Kansas Department of Agriculture
 Division of Water Resources
CHANGE: pu WORKSHEET

RE: Water Right, File Nos. 17680, 21508, 24108, 24122-D2, 31268, 33603

DWR FIELD OFFICE APPLICATION FOR APPROVAL TO CHANGE THE PLACE OF USE AND/OR THE POINT OF DIVERSION

GMD3 Change Review

Change Apps will
create a complete overlap
NO new acres added

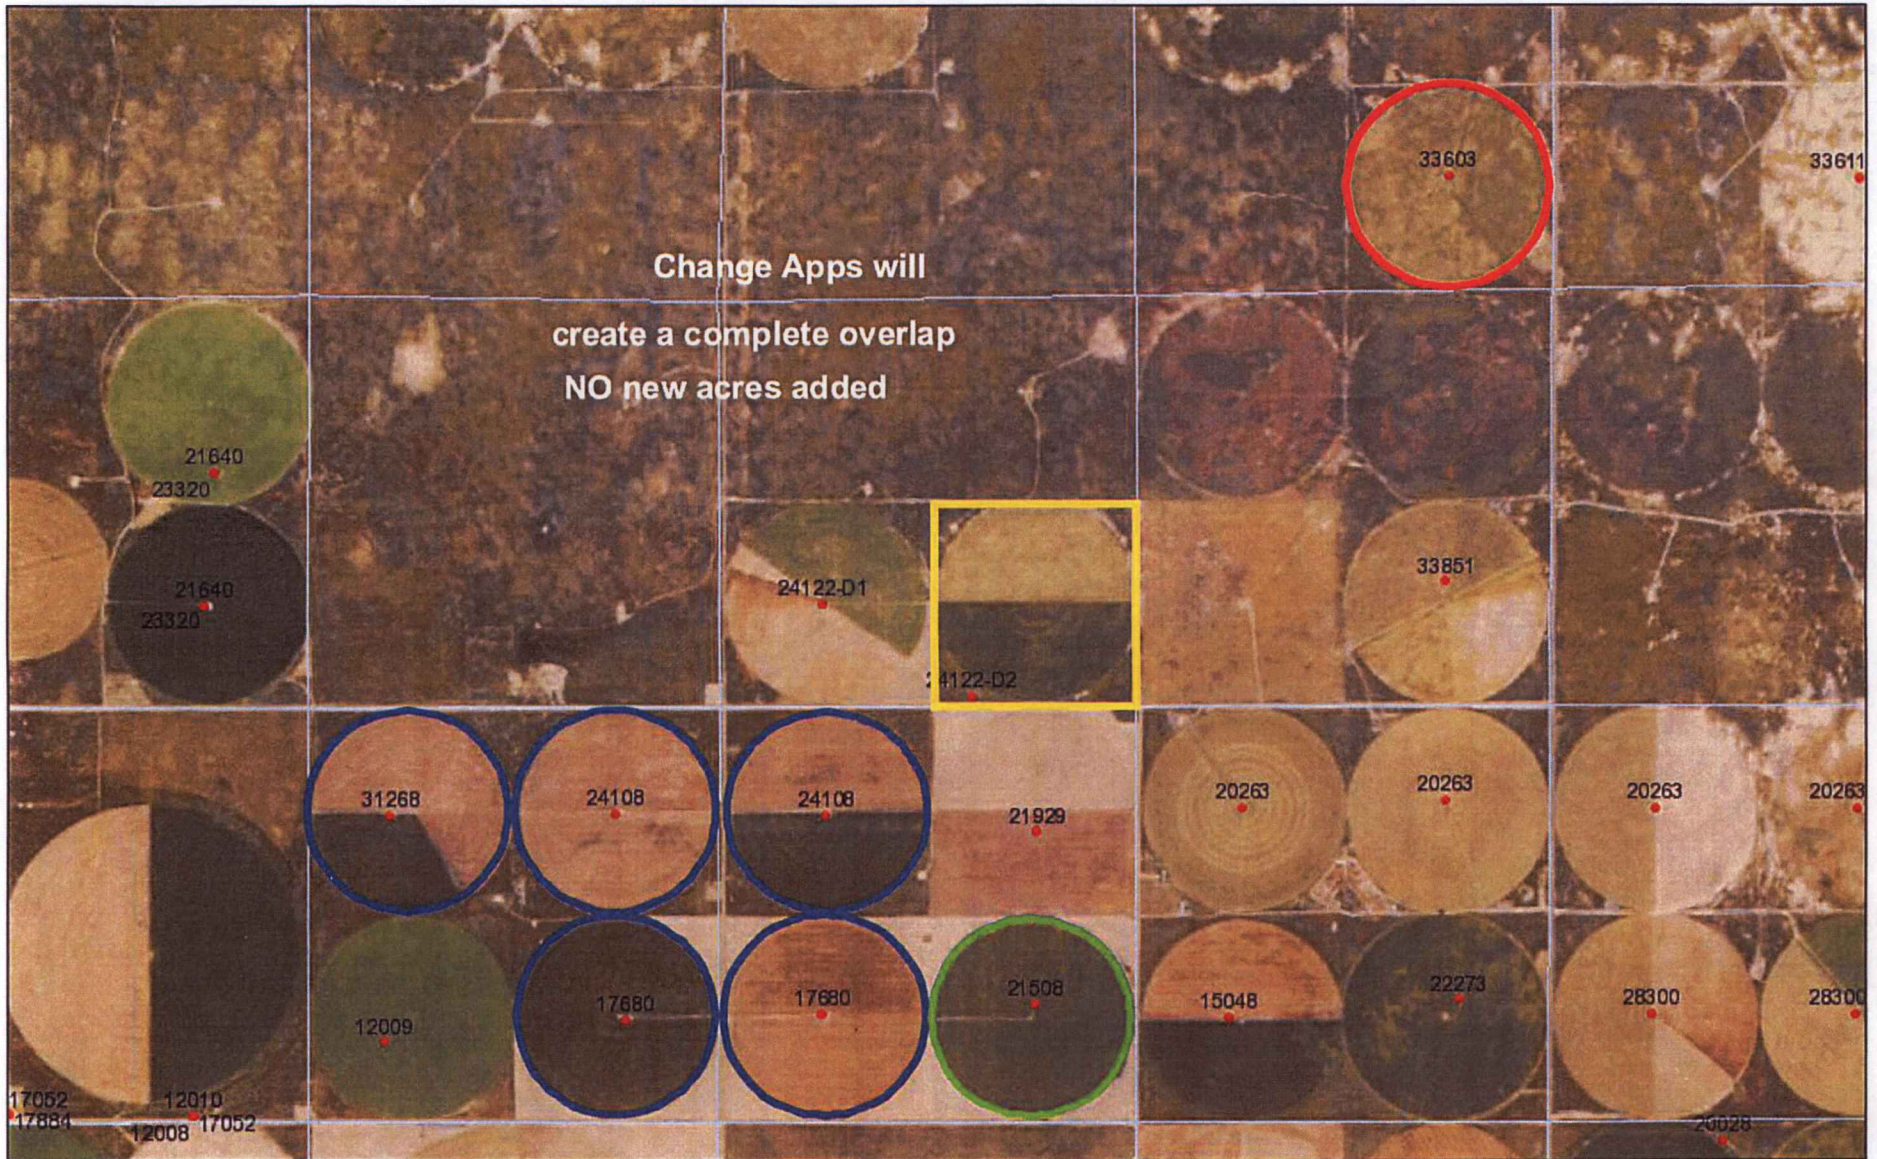
Is Proposed PU overlapping existing WRs? Proposal to make a complete overlap with all the WRs listed.

All proposed acres are covered by at least one of the WRs and no new acres being proposed.

Recommendation: The proposal meets the criteria for all current area rules and is not bring in any acres not currently covered by a water right. Staff therefore recommends approval of the application.
